1. Project Name: Agat SBH
2. Date of Inspection: June 7, 2002
3. Inspection Personnel:

AGAT SMALL BOAT HARBOR, GUAM

STRUCTURES	STATION
Main Breakwater	0+00 to 9+85
North Revetted Mole	0+00 to 3+00
South Revetted Mole	0+00 to 1+80
Stub Breakwater	0+00 to 0+60

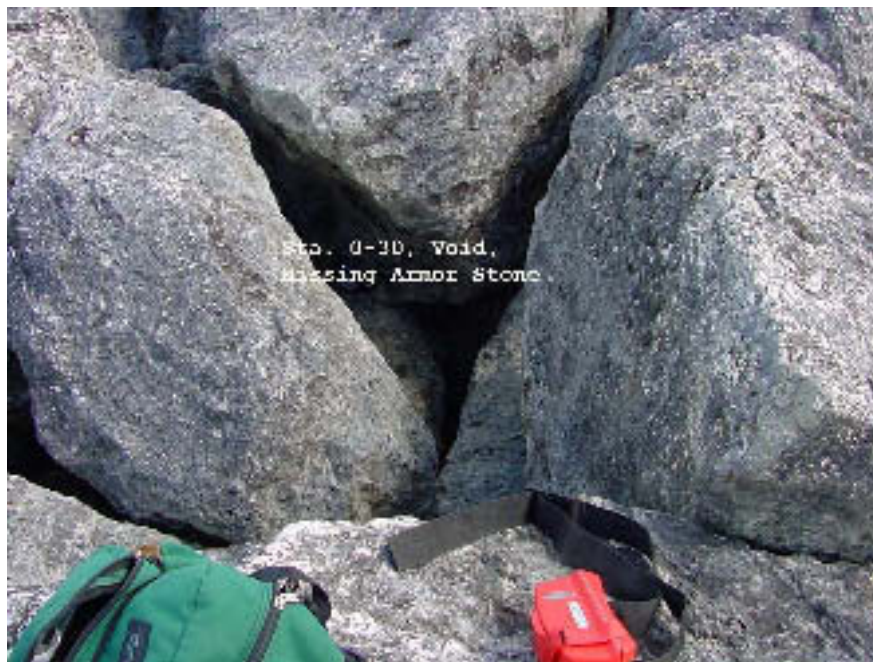
The Main Breakwater 985 LF, has minor encroachments (chains) on the crest (CL) and sideslopes of the structure both oceanside (OS) and the harborside (HS).

The North Revetted Mole, 300 LF, has a minor encroachment, which is the installation of a business sign at the crest. I spoke with Mr. Bill Bradford, Manager of JanZs Seafood Restaurant, Agat Marina and explained the structures ownership. Bradford stated the sign had been there for 8 years however, he would remove it. Other deficiencies are toe armor stone movement and vegetation.

The South Revetted Mole, 180 LF, was modified in the early 1990s. DPW or Ports may have done this modification. There are no updated AS-BUILT drawings for this work. The structure has well-established vegetation at the root section as the primary deficiency.

The Stub Breakwater, 60 LF has no noticeable deficiencies.

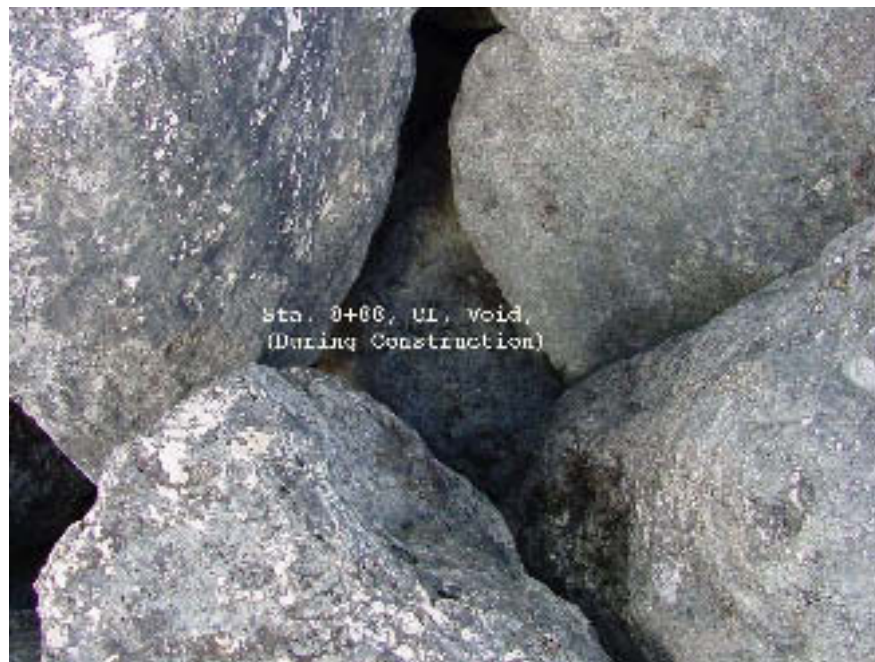
- p. Sta. 5+71, CL, Monitor slight settling.

q. Sta. 6+92, Overview (reference photo).

r. Sta. 7+35, OS, Remove chain.
